R44 SERVICE BULLETIN SB-112A
(supersedes R44 Service Bulletin SB-112)

DATE: 22 December 2022 **REV A:** 26 March 2024

SUBJECT: Tail Rotor Blade Inspection and Replacement

EFFECTIVITY: P/N C029-3 tail rotor blade S/Ns 14329 and prior (C029-3 REV Q and prior). Affected blades were factory-installed on the following aircraft:

SPECIAL TAIL ROTOR TIP PREFLIGHT INSPECTION

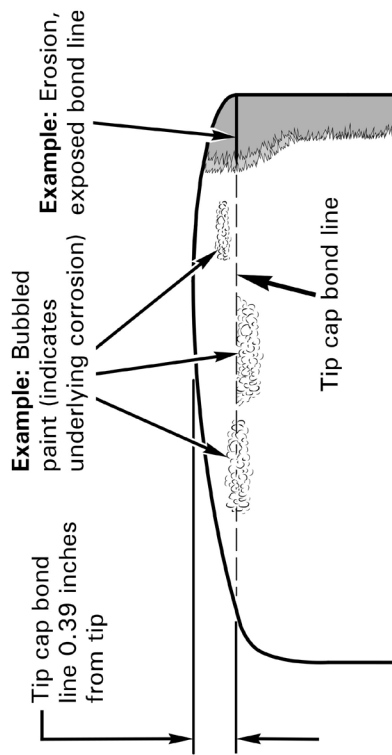
Refer to Figure below.

To be performed before the first flight of each day. May be performed by pilot or mechanic. Conduct visual inspection of tail rotor tip area. If bubbled paint or other evidence of corrosion is observed at or adjacent to tip cap bond line or if any portion of tip cap bond line is exposed, do not fly helicopter. Comply with latest revision of R44 SL-82 prior to further flight.
